ADDENDUM

Addendum #03
TO PLANS AND SPECIFICATIONS FOR
ELEMENTARY SCHOOL (ES-23)

March 02, 2020

SHEET
C1.13.01

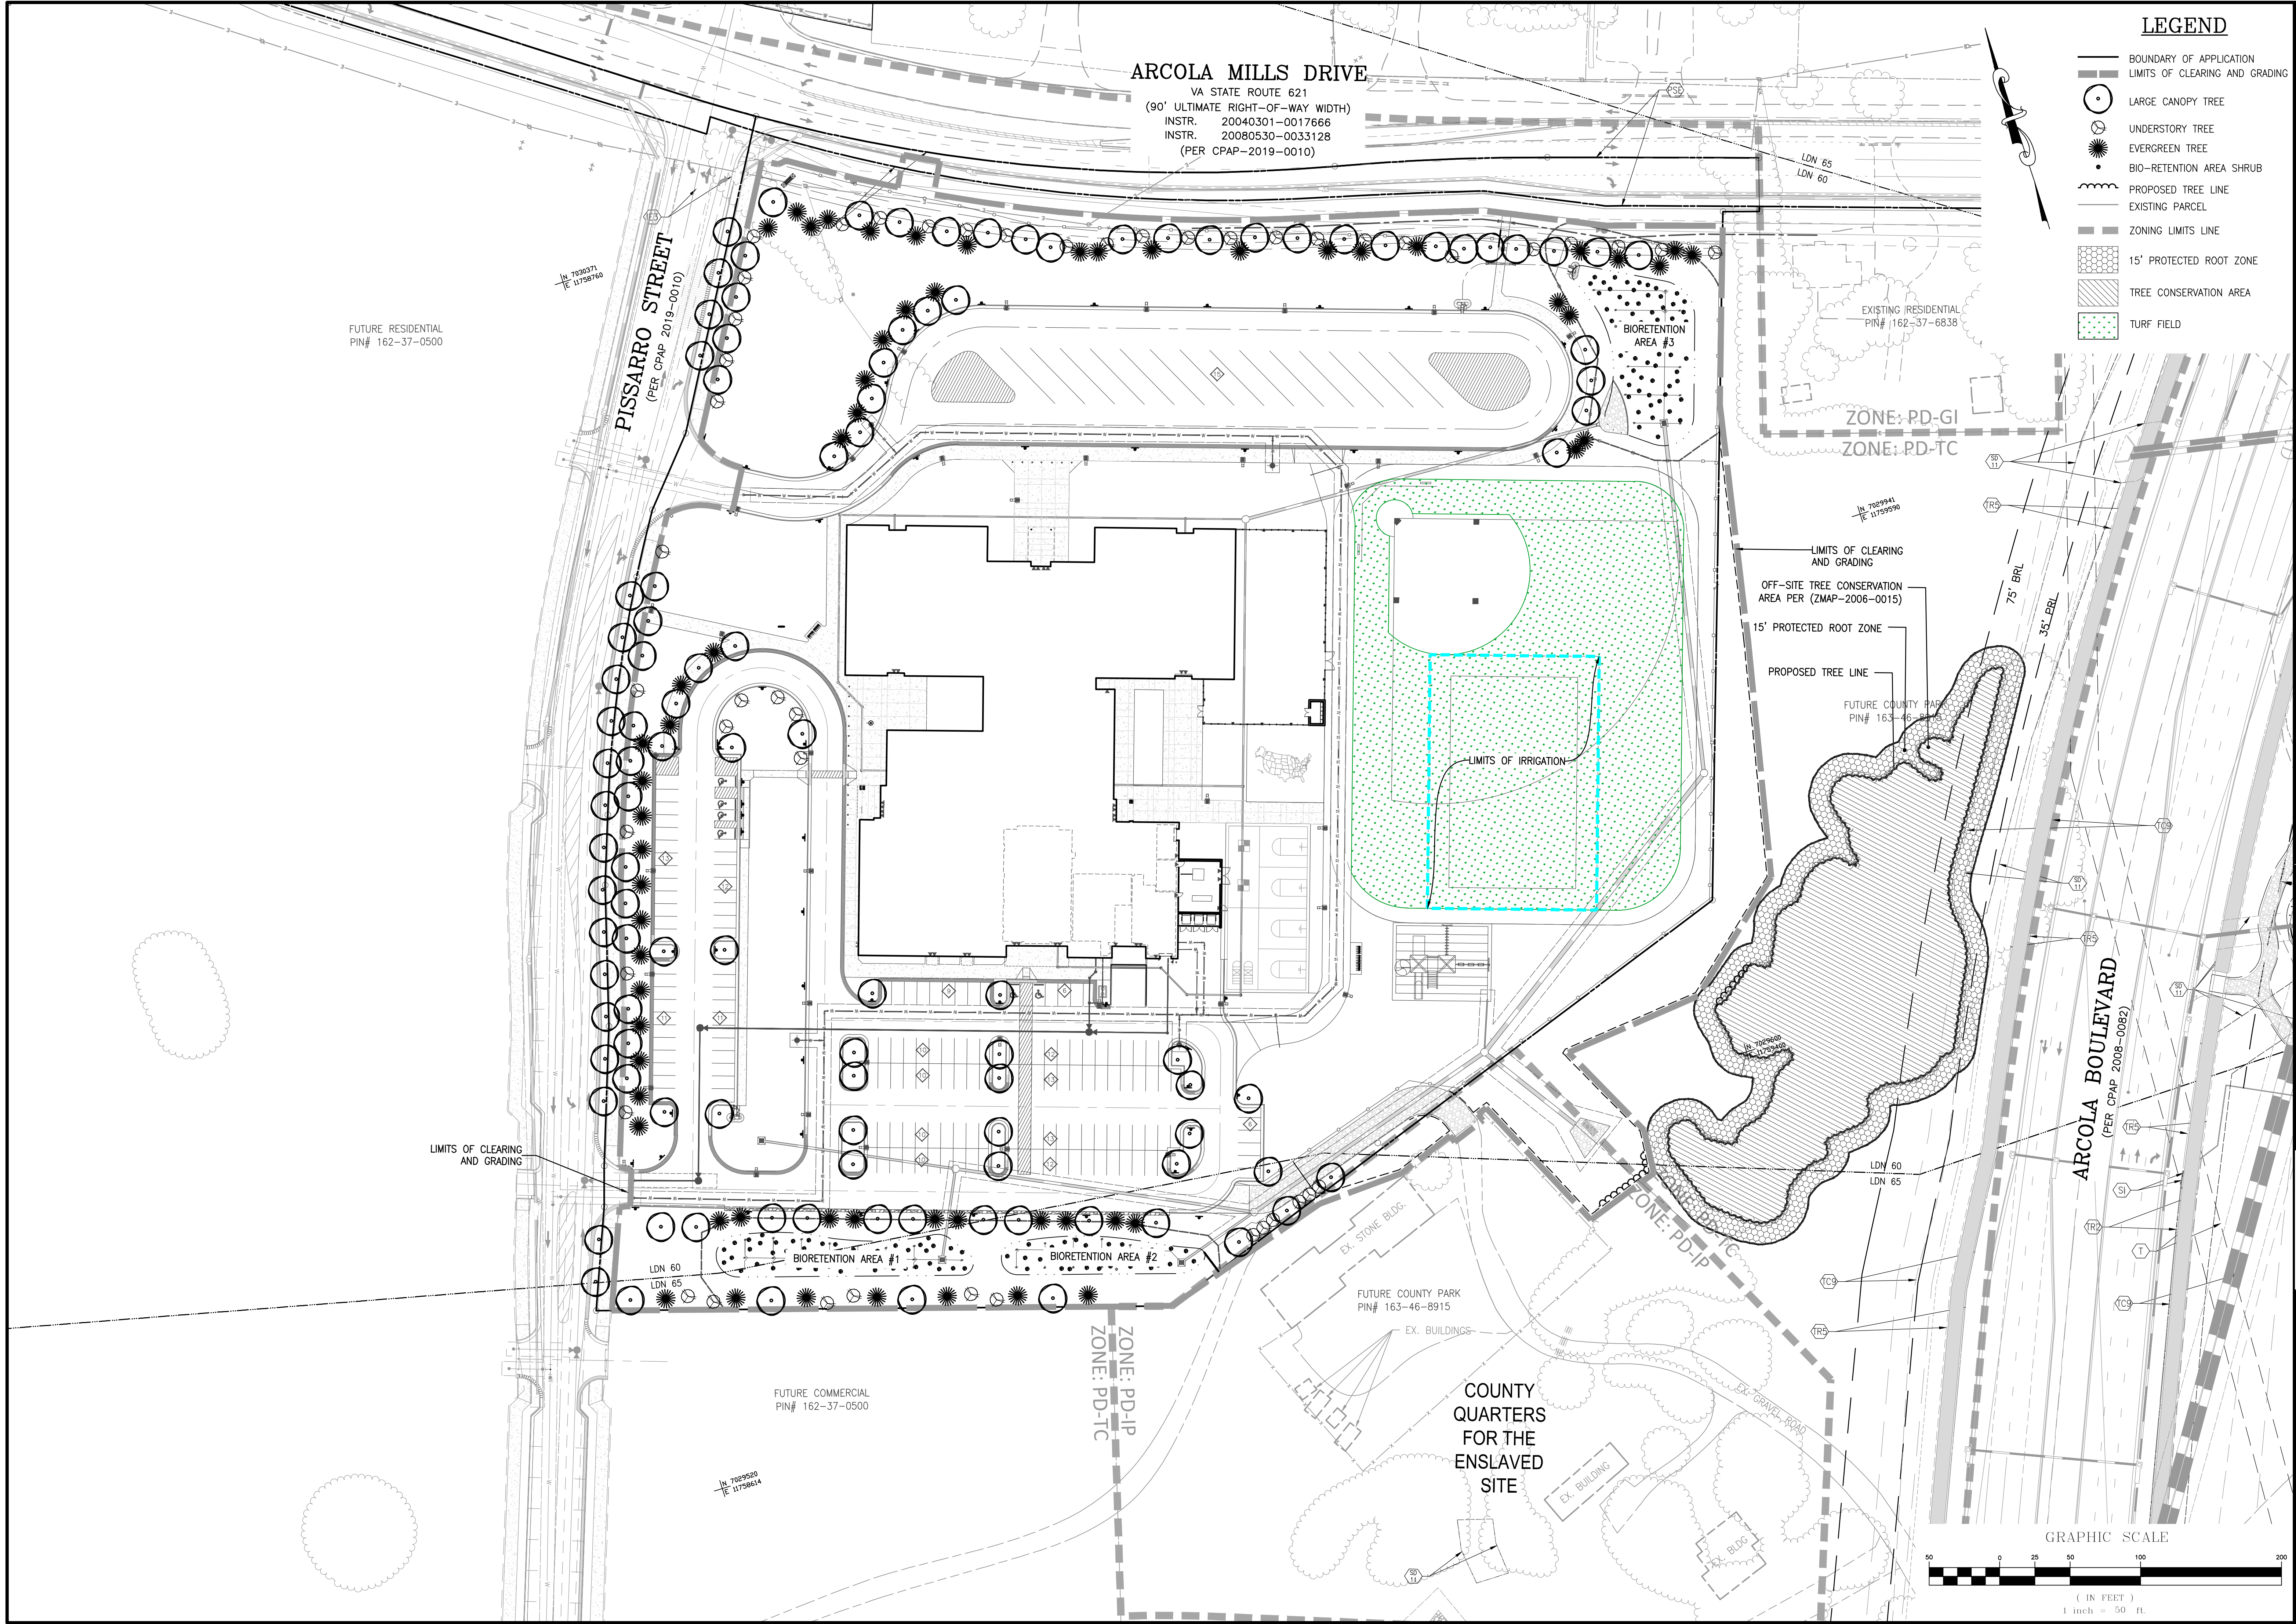
ITEM	SHEET NUMBER	DESCRIPTION
CD-1	C1.10.03	Inserted Sheet in its entirety to show LCPS Signage and Striping plan.
CD-2	C1.13.01	Inserted Sheet in its entirety to show Dry Utility Plan prepared by Davis Utility Consulting.
CD-3	Figure 1	Inserted exhibit in its entirety to show proposed field turf & irrigation plan

FIGURE 2

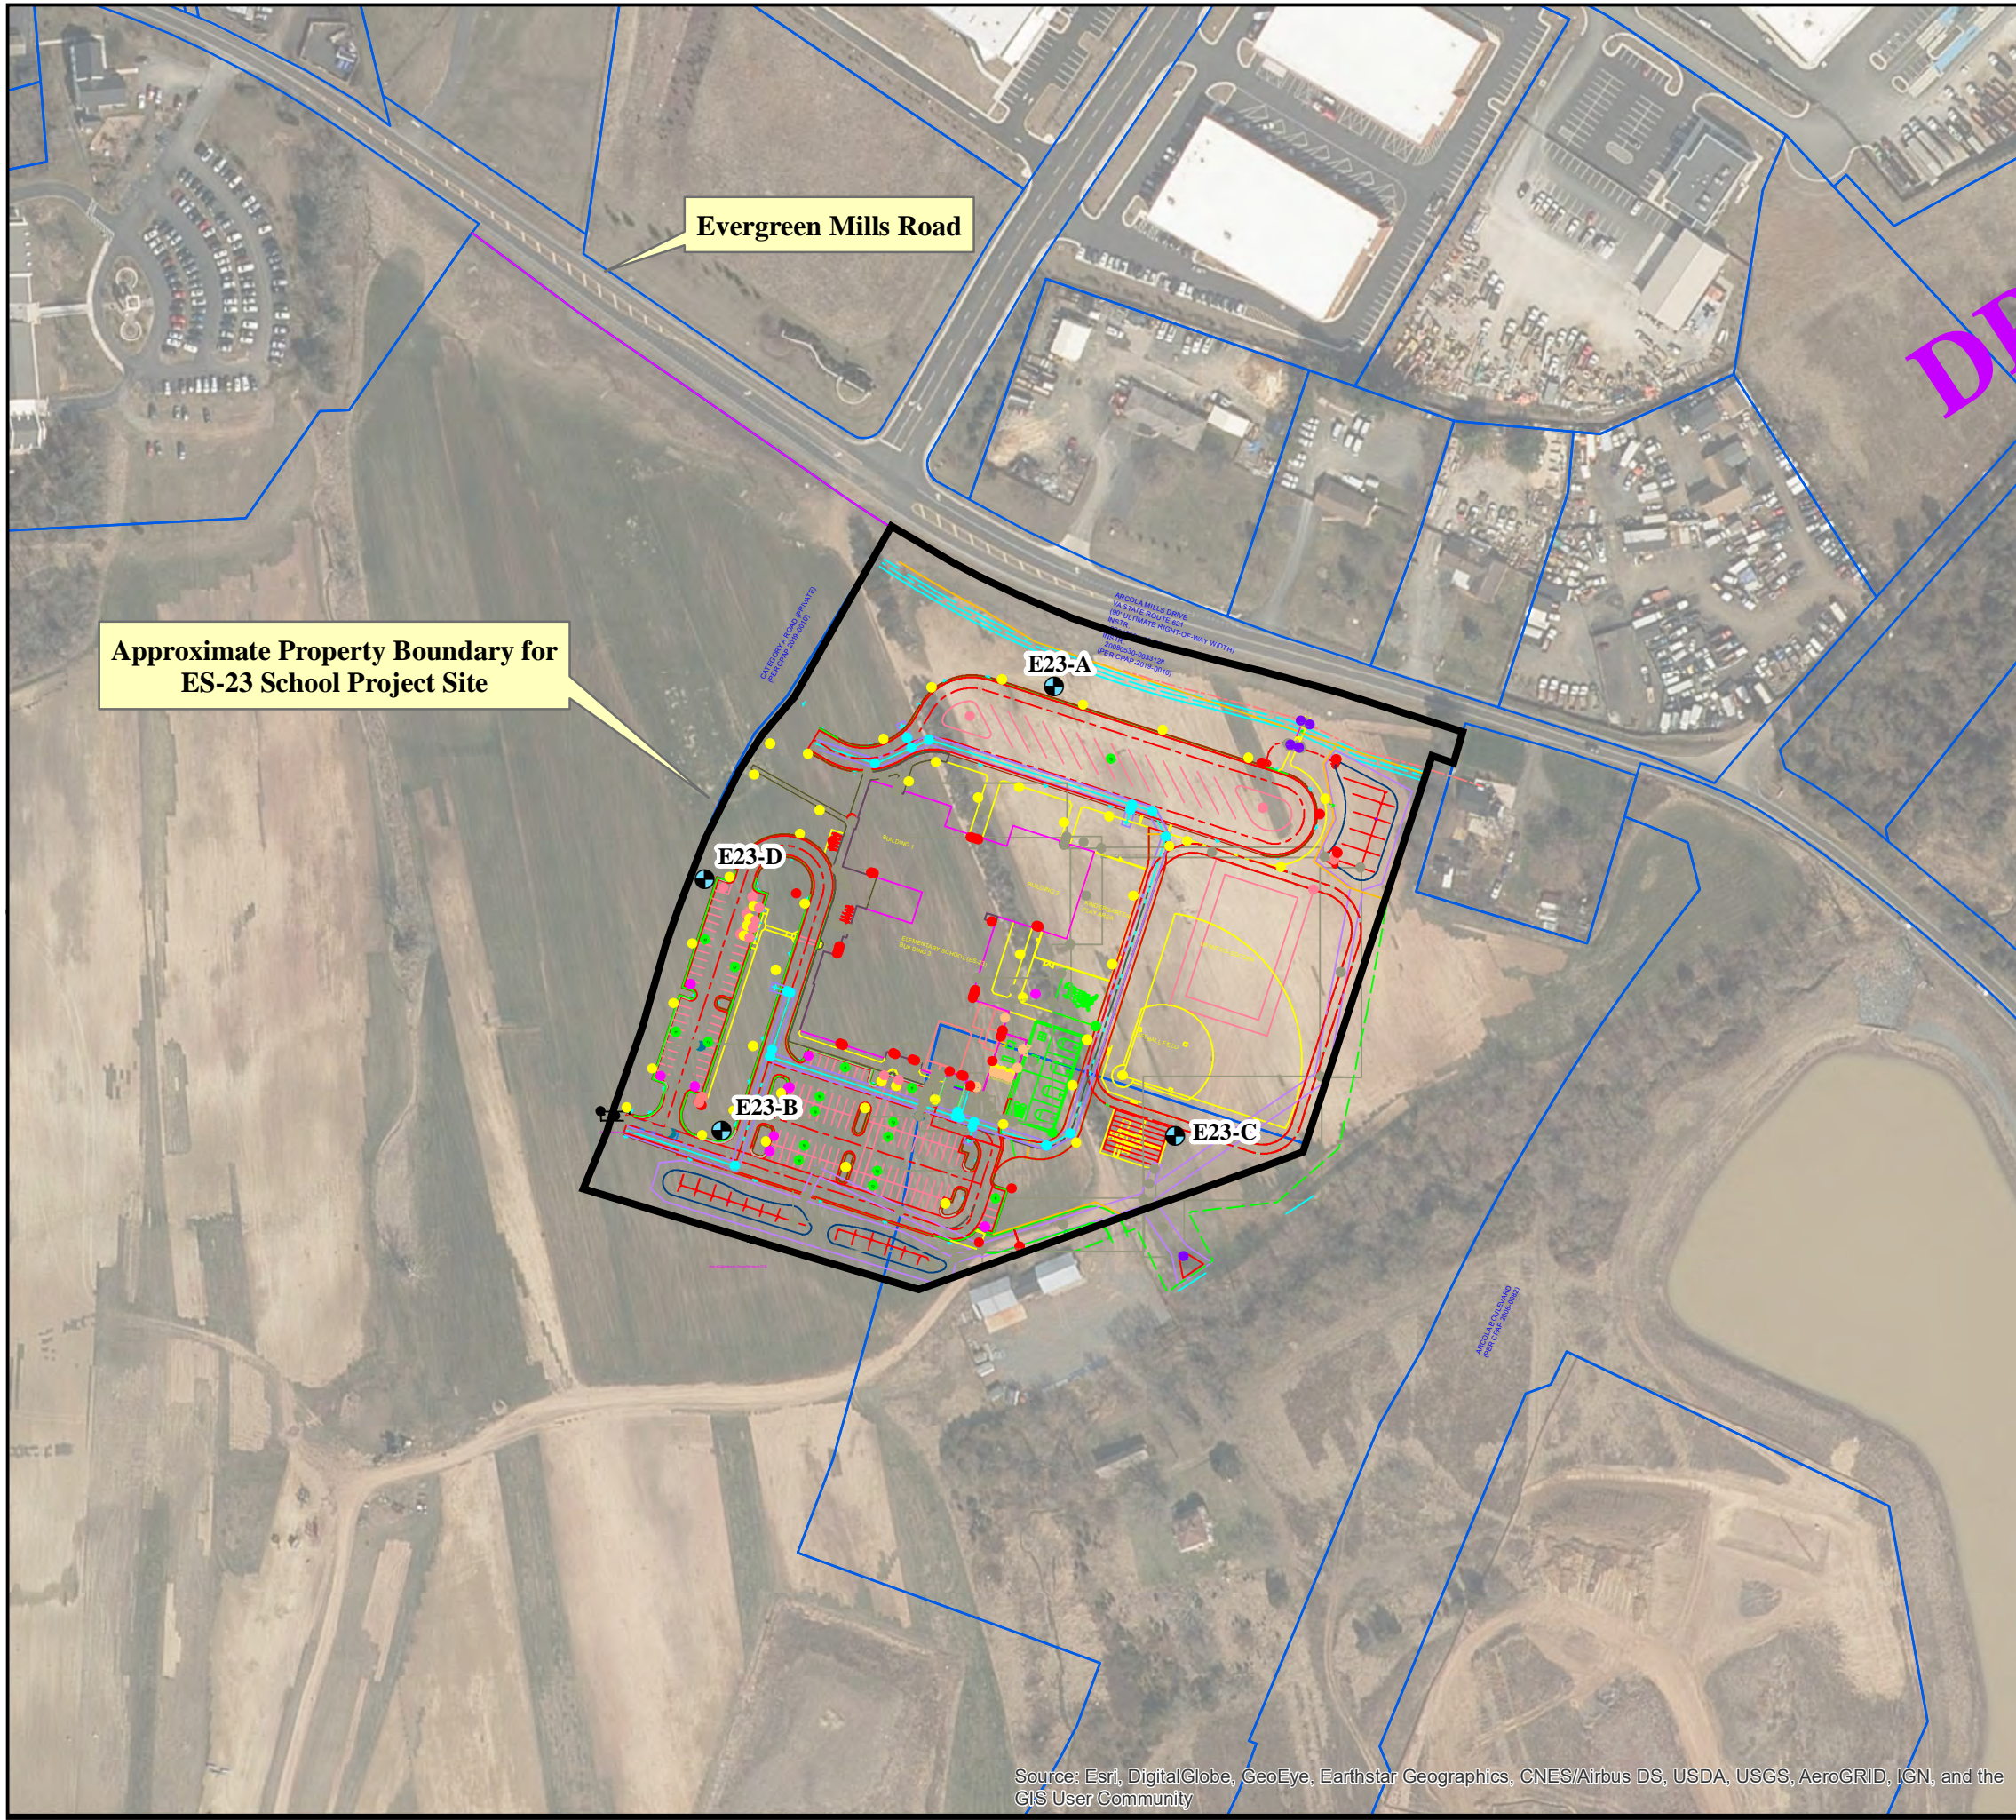
CD-4	Figure 2 – Draft	Inserted exhibit in its entirety to show proposed locations for exploratory test wells.
CD-5	C1.T1	Revised Sheet Index to include Sheets C1.10.03 & C1.13.01.

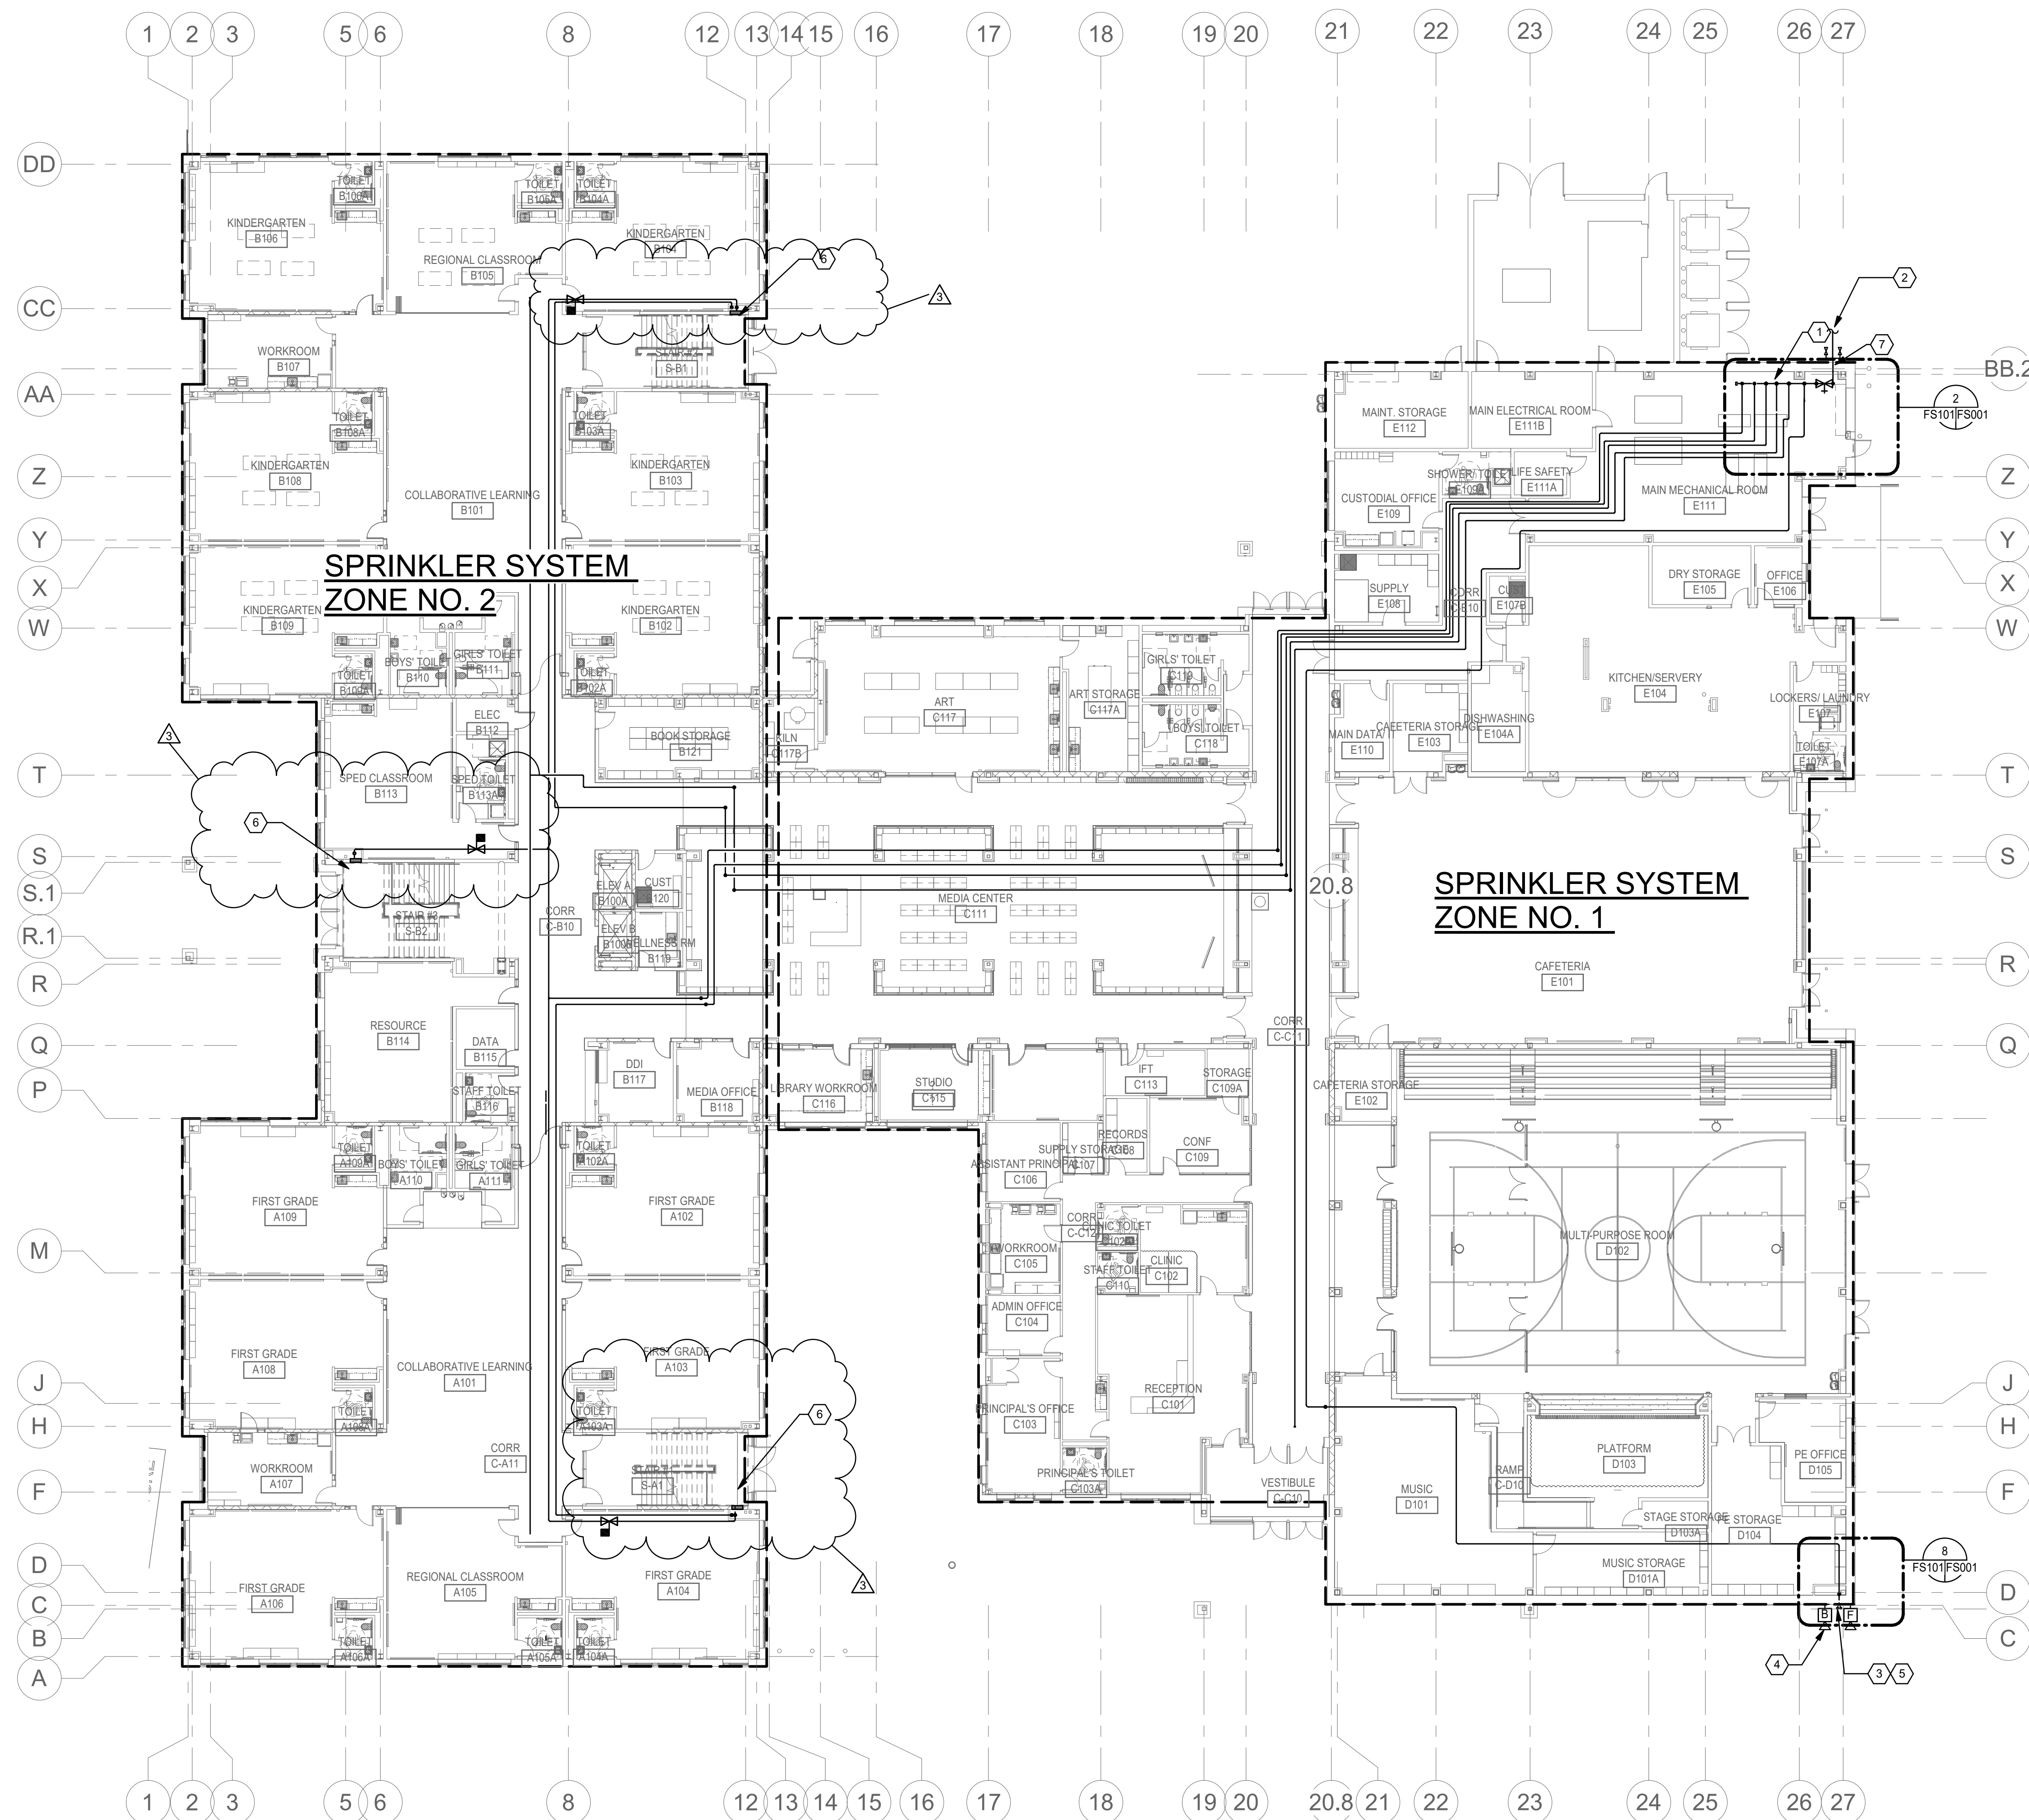
1. Sheet FS101:
 - Revised standpipe piping to be located outside of stair.
 - Revised Keynote.
2. Sheet FS102:
 - Revised standpipe piping to be located outside of stair.
 - Revised Keynote.
3. Sheet FS103:
 - Revised standpipe piping to be located outside of stair.
 - Revised Keynote.
